Approved Plans
LDA No. LDA2022/0358
Date: 13 July 2023
Council Officer: Niroshini Stephen
Subject to Conditions of Consent

AS21038 34 CLAYTON STREET, RYDE 2112

STORMWATER DRAINAGE PLAN

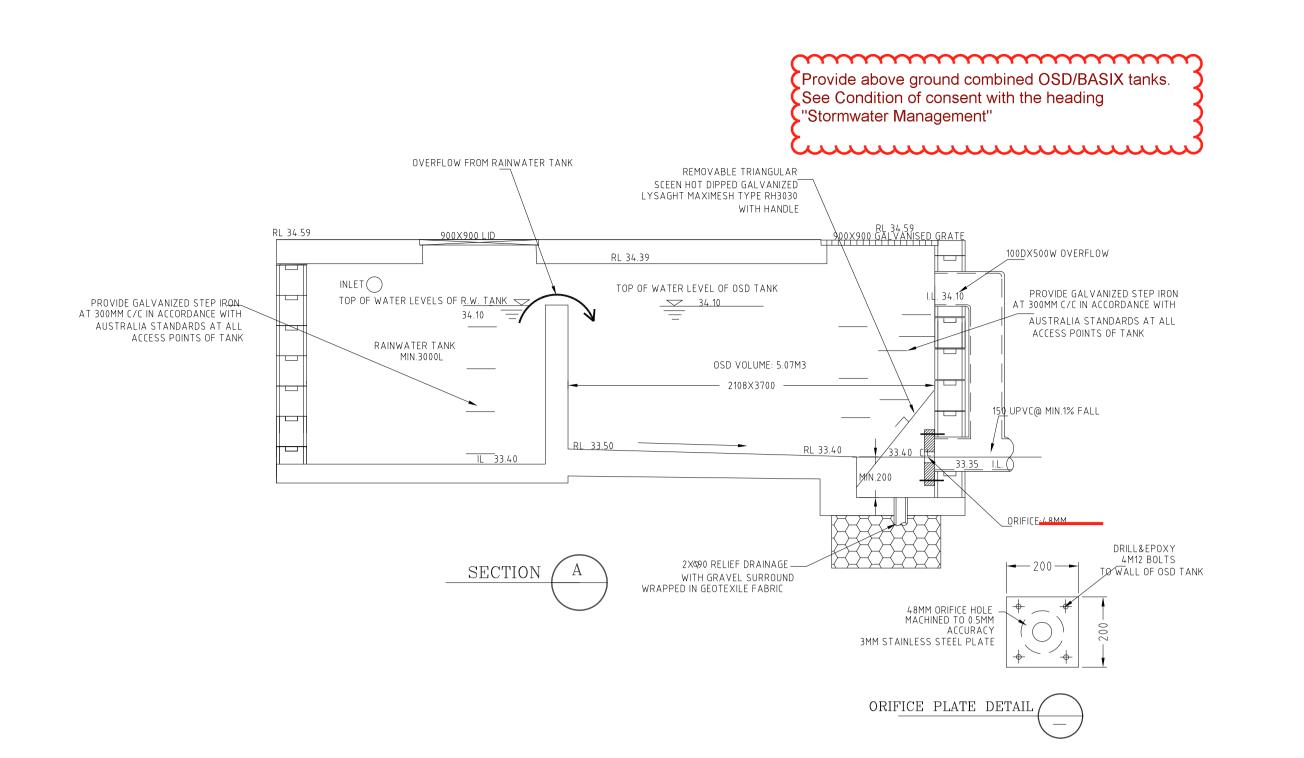
Provide above ground combined OSD/BASIX tanks. See Condition of consent with the heading "Stormwater Management"

STORMWATER DRAINAGE PLAN

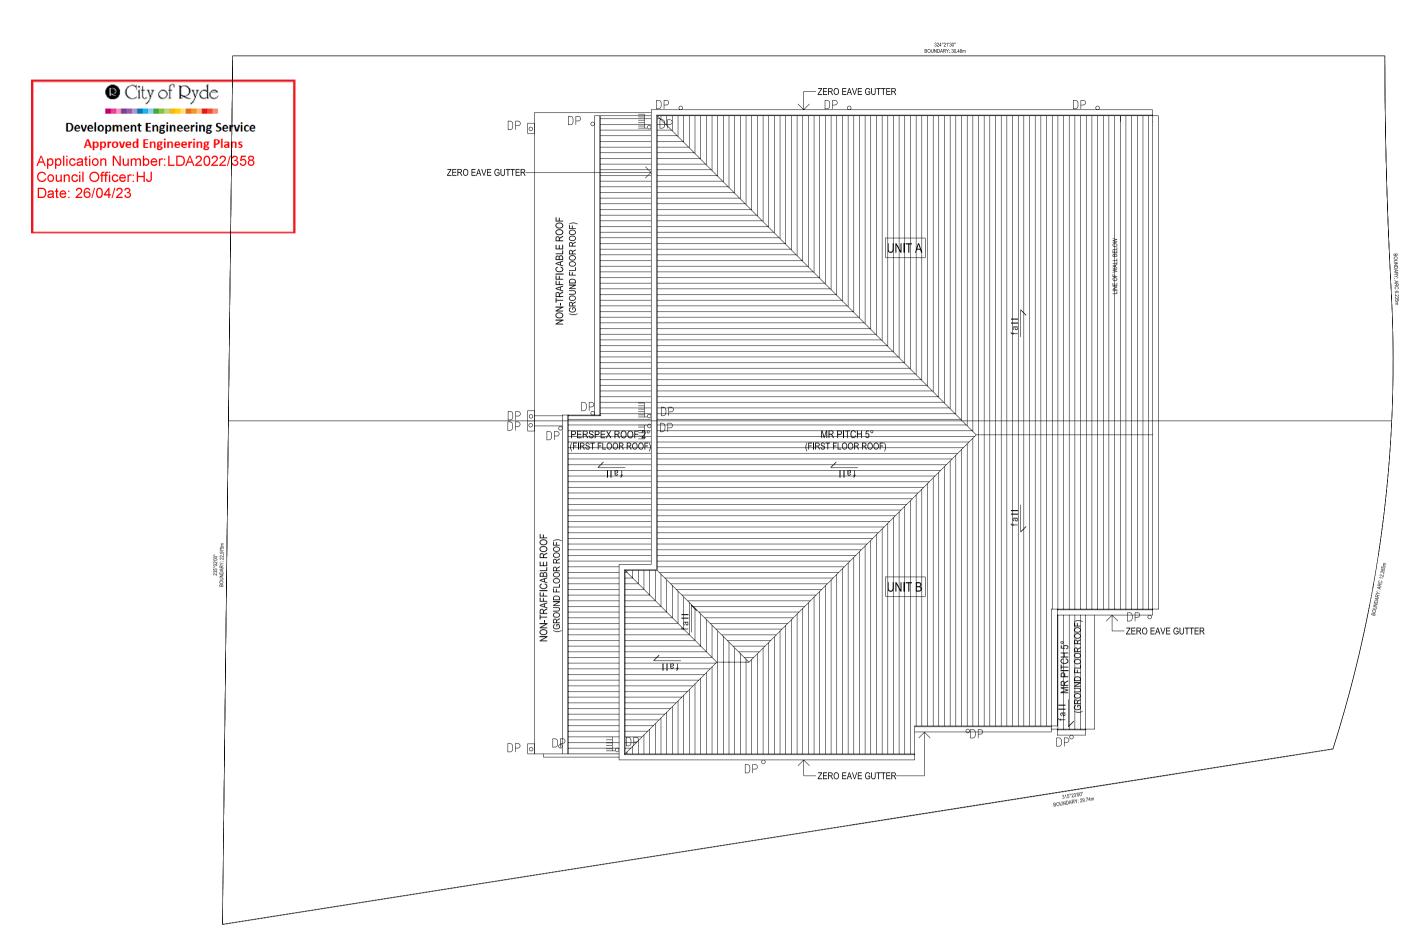
mProvide shallow dispersal trench. See Condition of consent with the heading "Stormwater Management PROVIDE TOTAL 36 VERSITANKS(VT 550) INSTALLATION REFER TO MANUFACTURER'S SPECIFICATION AND DETAILS
